# Federal Register

Wednesday,  
September 6, 2006

**NESHAP: National Emission Standards for  
Hazardous Air Pollutants: Standards for  
Hazardous Waste Combustors  
(Reconsideration); Proposed Rule**

**NESHAP: National Emission Standards for Hazardous Air Pollutants: Standards for Hazardous Waste Combustors (Reconsideration)****AGENCY:** Environmental Protection Agency (EPA).**ACTION:** Proposed rule.

**Figure 1. Time Line for Phase 1 Replacement Standards and Phase 2 Standards – Existing Sources**

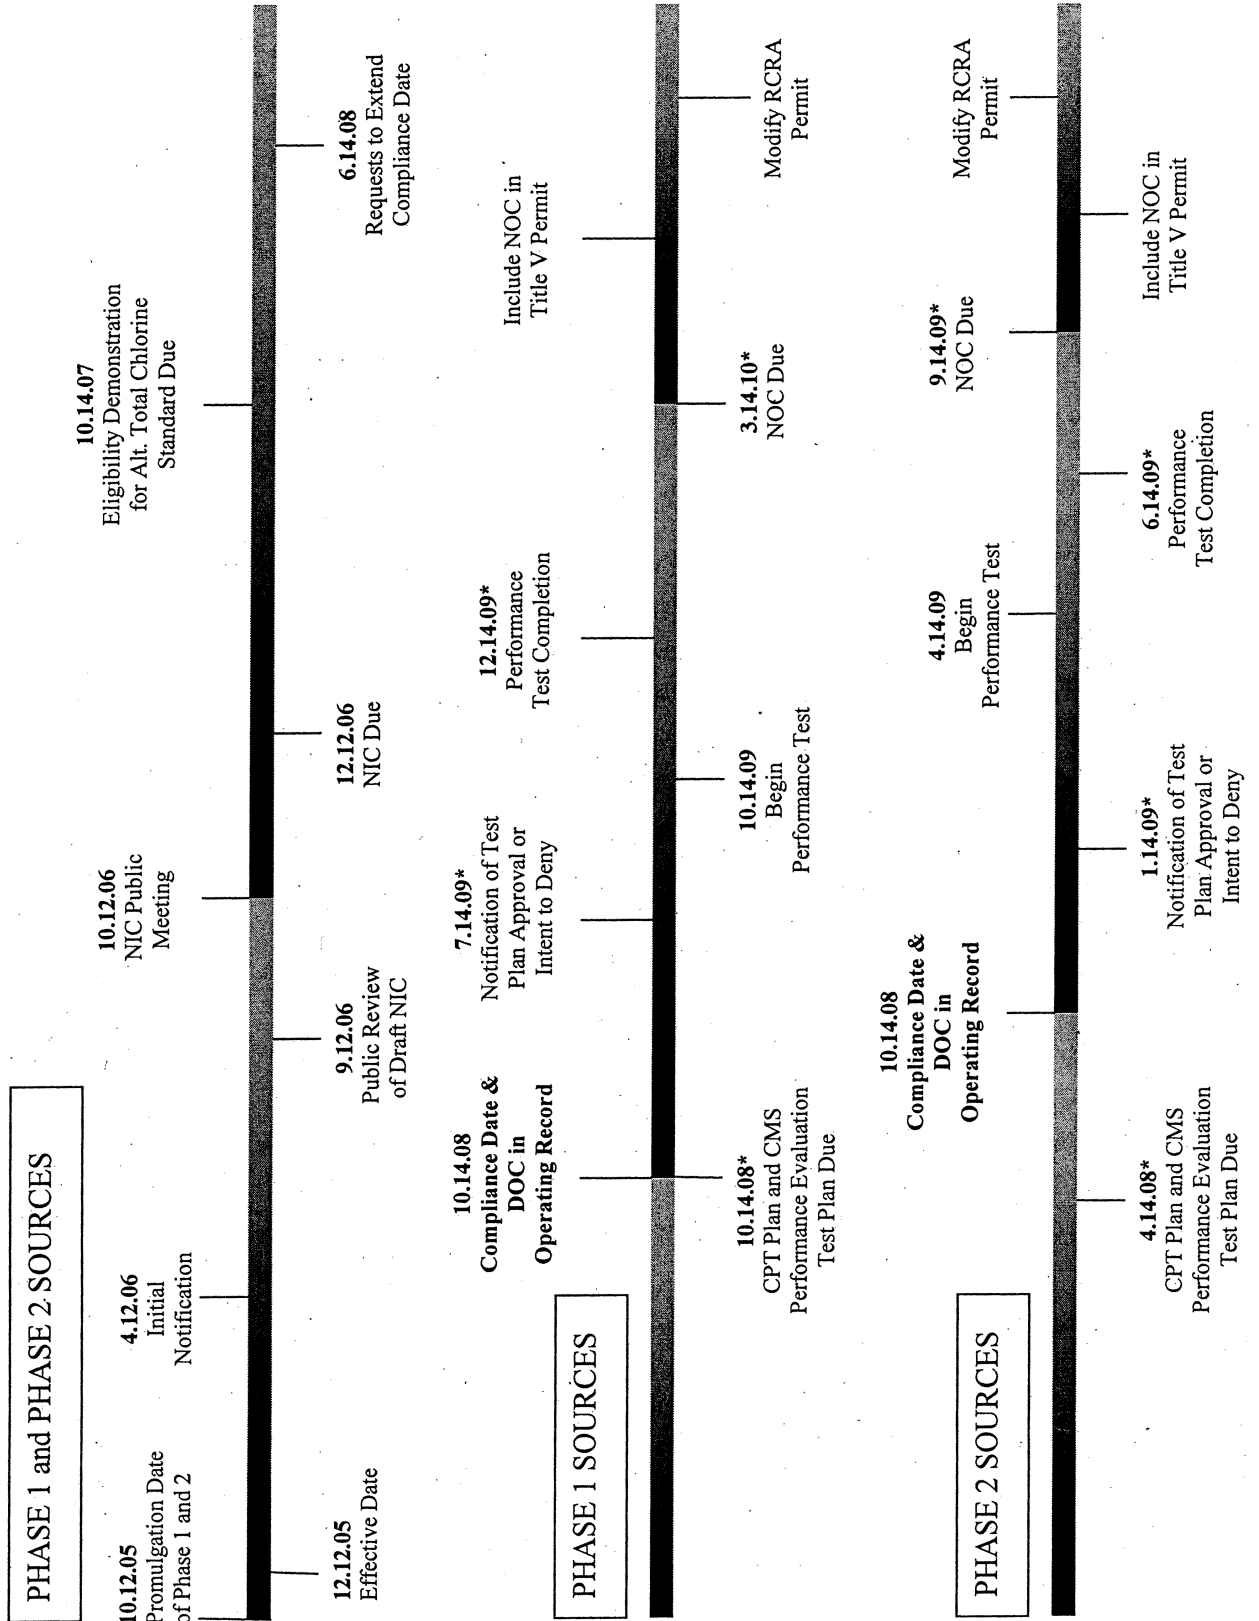
The time line labeled as Figure 1 published in the final rule at 70 FR at 59524, depicts an incorrect "effective" date for the Phase 1 Replacement Standards and Phase 2 Standards final rule. As a result, all subsequent dates on the time line are also incorrect. The time line labeled as Figure 2 published in the final rule at 70 FR at 59525 incorrectly includes the rule's effective date, as well as subsequent dates based on the effective date. Today's notice revises both time lines to reflect the correct dates or time frames associated with the compliance activities for both Phase 1 and Phase 2 sources. In addition to revising the dates, we felt it would be helpful to include the following remarks for both Figures 1 and 2.

With respect to figure 1, the time line is now broken into three sections to reflect the separate requirements (*i.e.*, different time frames) negotiated for Phase 1 sources for the Replacement Standards. The first section of the time line, beginning with the promulgation date, provides compliance activities and dates applicable to both Phase 1 and Phase 2 sources. The second and third portions of the time line represent Phase 1 and Phase 2 sources individually, beginning with the first compliance activity that specifies a different deadline; that is, the comprehensive performance test (CPT) plan and continuous monitoring system (CMS) performance evaluation test plan due date.

Note that the dates on the time line generally do not apply to sources that elect to comply with the final standards early, as well as to sources that have received site-specific compliance date or performance test date extensions. Also, as a result of expanding the time line into three sections from the previous two, we have removed the note at the bottom of the page, identified by an asterisk that discussed Title V requirements, to provide better visual clarity. Rather, we have chosen to

Finally, the compliance activity dates that are tied to when sources commence their performance test are identified with an asterisk. We characterize these dates as "no later than dates." This assumes that the source commences testing on the last allowable day. All compliance activities marked with an asterisk would therefore shift back by the number of days the source commences testing prior to the last allowable day. For example, if a Phase 2 source commences testing on April 4, 2009 (versus the 14th, which is the last allowable day without an extension), then it must submit its CPT plan and CMS performance evaluation test plan on April 4, 2008. Also, that source must complete its CPT by June 4, 2009 and submit its notification of compliance no later than September 4, 2009.

**Figure 2. NIC and CPT Plan Time Line - New Units**

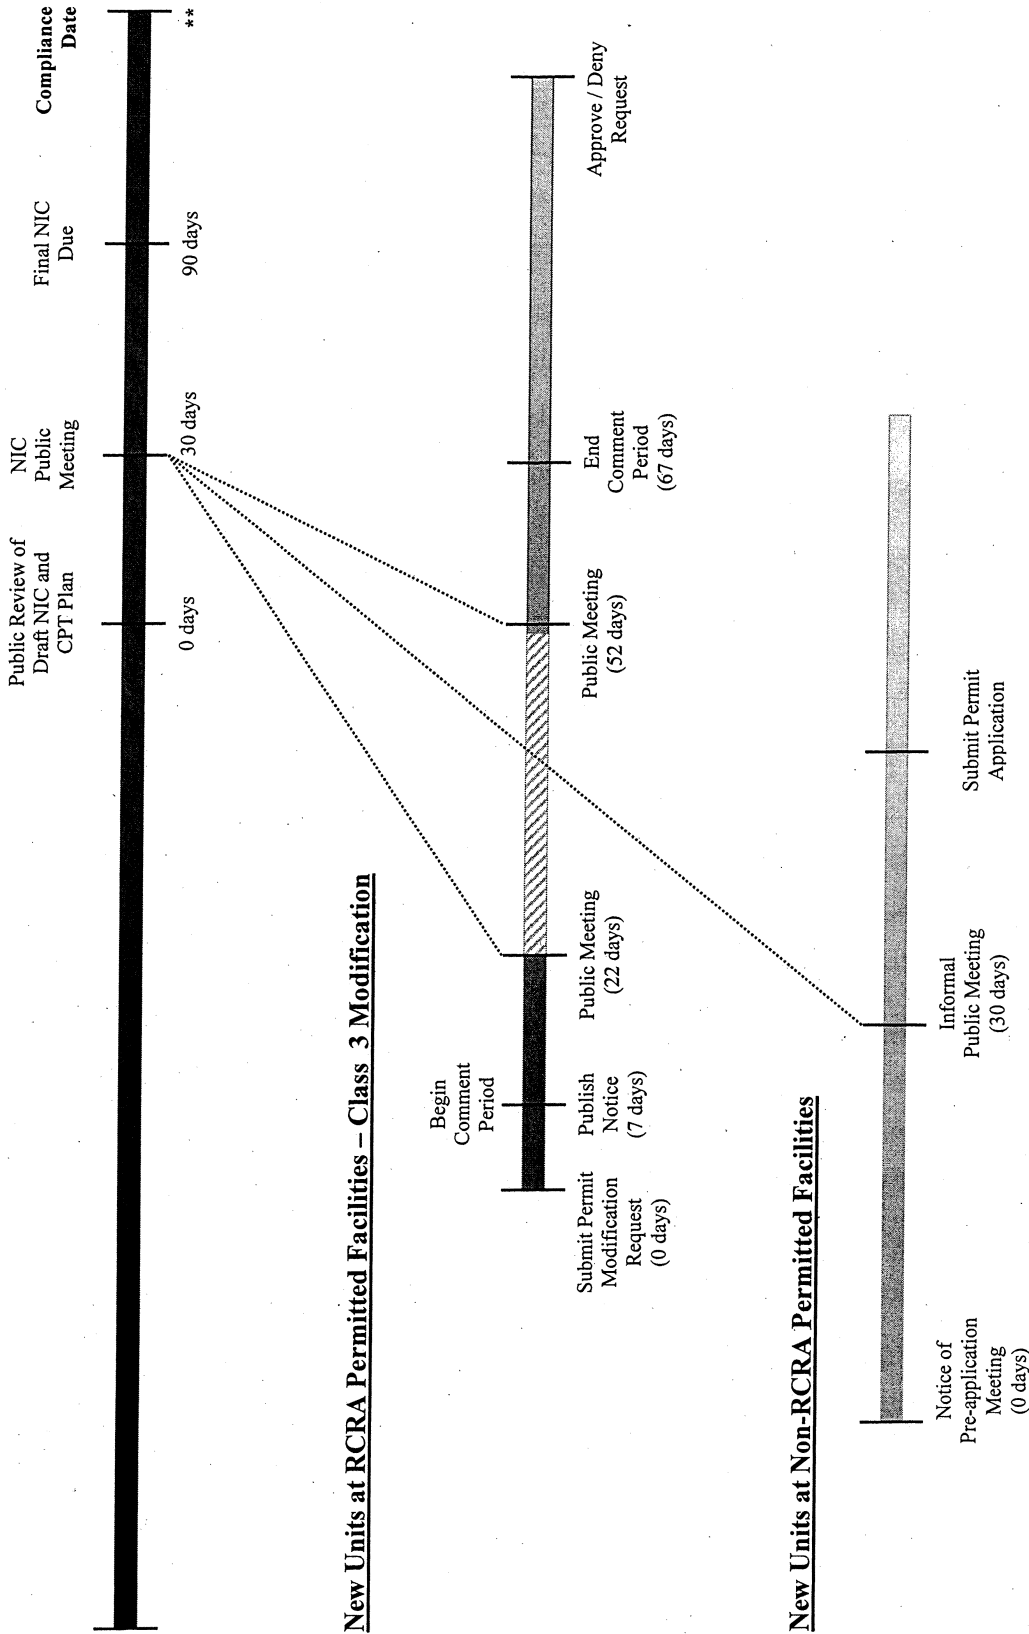
In regard to Figure 2, we have removed the dates from the time line, since they would not be representative of a new unit's compliance deadlines. A new unit's compliance activity deadlines are based on when it begins operations, which is the unit's compliance date and the date it must place a Documentation of Compliance in the operating record. Thus, the effective date of the rule is not applicable to new units and consequently, the Notice of Intent to Comply (NIC) provisions in §§ 63.1210(b)(3) and (c)(1) that specify a deadline based on the effective date of the rule, also would not apply. Since we have always intended that new units follow the same NIC procedures as existing units, we have revised §§ 63.1210(b)(3) and (c)(1) to also include the period of time between the NIC activities so that they correctly apply to both existing and new units. (See Section VII.C (Clarifications to the NIC Provisions for New Units) below for additional discussion.) The time line now reflects the period of time that elapses between public review of the draft NIC and CPT plan, the NIC public meeting, and the final NIC submission deadline. Aside from the corrections

While revising the time line for new units (see Figure 2 shown above in Section VI (Revised Time Lines)) it became apparent that we overlooked the fact that the final rule's effective date has no bearing on new units. A new unit's compliance activity deadlines are based on when it begins operations, which is the unit's compliance date and the date it must place a Documentation of Compliance in the operating record. Therefore, the NIC deadlines are only based upon each individual NIC compliance activity. For example, the clock will begin when the new unit provides the draft NIC and draft CPT plan to the public for review. Once the draft NIC and draft CPT plan are made available for public review, the combined public meeting must occur 30 days later, followed by the final NIC submission an additional 60 days later. Since the public meetings for the NIC and the RCRA pre-application or modification request must occur simultaneously, we anticipate that the new unit will plan accordingly and work with its permitting authorities to determine the most suitable time to begin the NIC compliance process.
